Logos Development Management Pty Ltd
Access Design Assessment Report

SSD-47601708
Sydney Flight Training Centre
28-30 Burrows Road
St.Peters NSW 2040

Project: SSD-47601708 Sydney Flight Training Centre
Document Type: Access Design Assessment Report
Our Reference: P222_132-3 (ACCESS) KG

Figure 1 – Pedestrian Entries

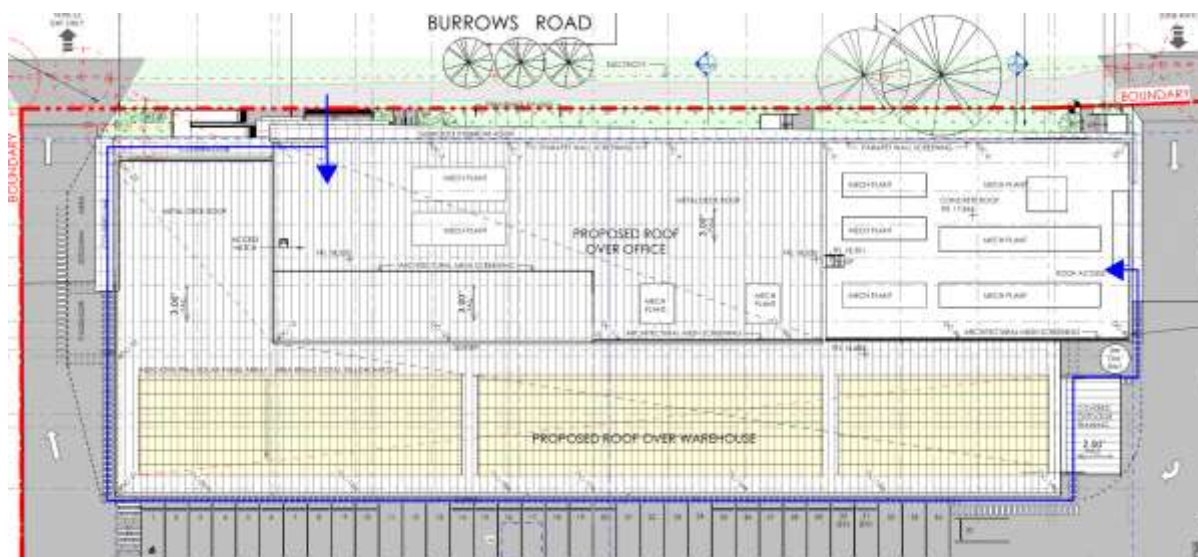
DESCRIPTION	COMPLIANCE DEPARTURE	RESOLUTION
Pedestrian entries	Building over 500m ² area requires all entrances to be accessible or within 50m of an accessible entry.	Provide entry as an accessible entry. Alternatively, a performance solution can be provided to justify employee entry as not accessible (This will

DESCRIPTION	COMPLIANCE DEPARTURE	RESOLUTION
		include an access management plan).
Entry stairs – setback	Ensure minimum 900mm distance is provided from the edge of stairs to site boundary to accommodate stair handrails and TGSIs on the proposed lot.	Nil further action required at this stage.
Handrails – traverse path of travel	Drawings indicate reduced width between handrail extension to the top of stairway and edge of the building is provided.	Even though not an access issue, reduced width of less than 1000mm on the path from fire stair 1 should be consulted with the BCA consultant.
Employee entry – turning space	Reduced turning space on the accessible path of travel to employee door is provided.	Provide 90 degree turning space 1500x1500mm with a splay on a grade not less than 1:40 as per Figure 4 of AS1428.1-2009.
Accessible path of travel – employee entry	A path of travel from site boundary on Burrows Road to employee entry is provided besides rear of the building and through rear car parking areas.	Ensure accessible path of travel to employee entry is provided in compliance with AS1428.1-2009. Minimum 1000mm width, turning spaces (1540x2070mm) every 20m and passing space every 20m where direct line of sight is not available.

Ground Floor Plan

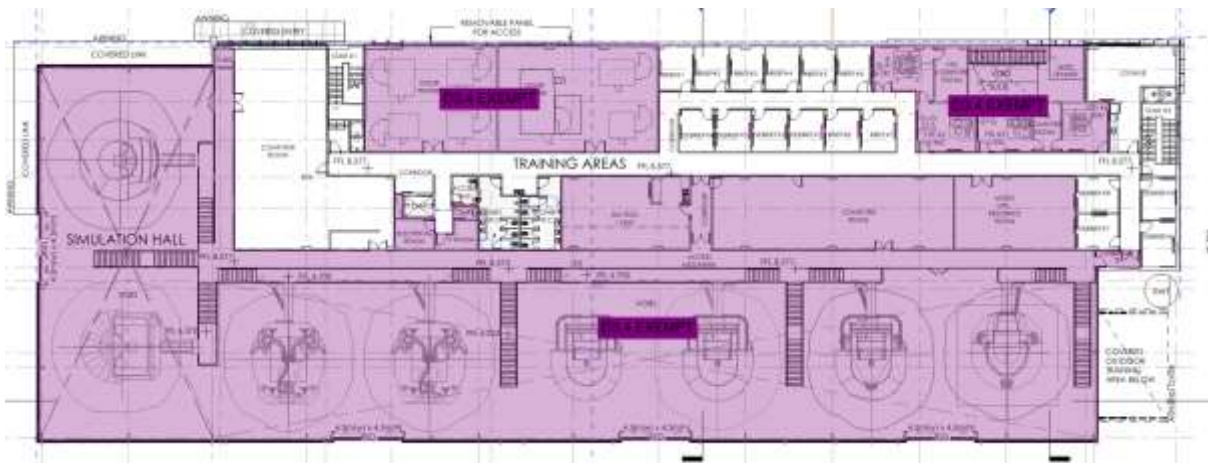
DESCRIPTION	COMPLIANCE DEPARTURE	RESOLUTION
Security entry – circulation area	Door from reception area to the back rooms is provided with reduced latch side clearance. Refer to Appendix 3 for areas at concern.	Provide minimum 530mm latch side clearance to doors externally and 510mm latch side internally.
Locker areas – door circulation	Doors leading to female and male locker areas are provided with reduced latch side clearances. Refer to Appendix 3 for areas at concern.	Access to lockers must be provided. Ensure door circulation areas are free of any obstructions (water fountains). Provide 340mm hinge side clearance (externally) and 530mm latch side clearance (internally) to both doors.
Successive doors – circulation space	Doors leading towards employee entry/exit are provided with reduced circulation area in the airlock due to successive doorways in corridors.	Provide minimum 1450mm between successive doors as per Figure 34 (a) of AS1428.1-2009 requirement.

DESCRIPTION	COMPLIANCE DEPARTURE	RESOLUTION
Hand transfer	All three toilets are provided as right-hand transfer toilets.	Provide a balance between left- and right-hand transfer toilets (50-50).
Ground floor facility –	Sanitary facility on the ground floor level is proposed with reduced	Opt 1: Provide circulation area clear of any obstructions. Minimum

DESCRIPTION	COMPLIANCE DEPARTURE	RESOLUTION
circulation areas	shower and toilet pan circulation areas. Refer to Appendix 3 for areas at concern.	2700mm wide room required (in lieu of 2300mm). Opt 2: A performance solution can be provided to justify reduced circulation spaces. This will require the room size - width to be 2400mm in lieu of 2300mm. Opt 3: Provide different layout with required circulation areas (bigger room size) – 2350mm x 2650mm minimum.
Detailed drawings	Detailed drawings have not yet been provided for an assessment.	Level of detail is suitable for DA stage. As design progresses detailed drawings in compliance with Clause 15 of AS1428.1-2009 will be required.

Level 2 Floor Plan

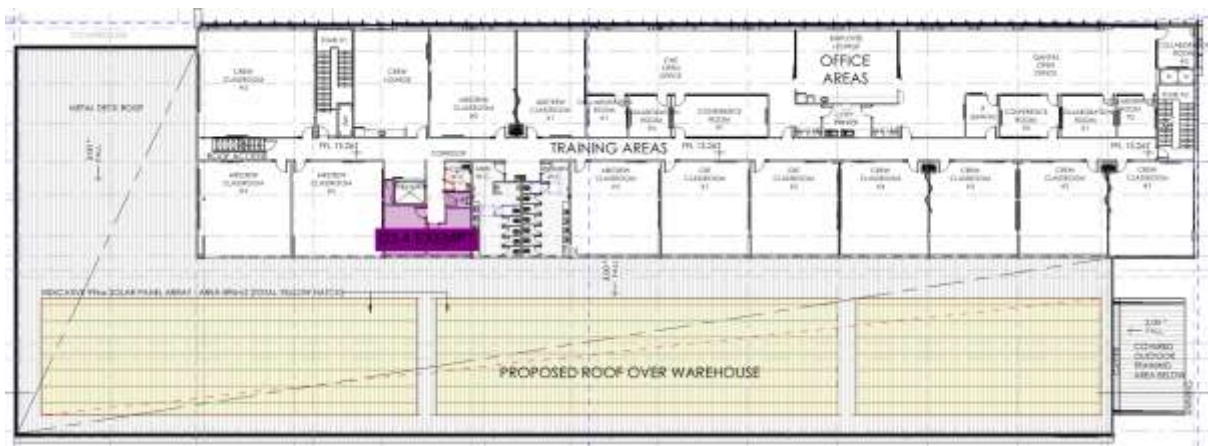
DESCRIPTION	COMPLIANCE DEPARTURE	RESOLUTION
Level 2 office areas – door circulation	Sliding doors are proposed with reduced latch side clearance. Refer to Appendix 3 for areas at concern.	Provide minimum 530mm latch side clearance to sliding doors from both sides of the door.
Doors – general	Ensure all doors on the accessible path of travel achieve minimum 850mm clear opening and circulation spaces in compliance with Clause 13 of AS1428.1-2009.	No further action required at this stage.
Door controls	Door that are provided as automated must have door controls located as per Clause 13.5 of AS1428.1-2009. Alternatively, a sensor opening can be provided.	No further action required at this stage.
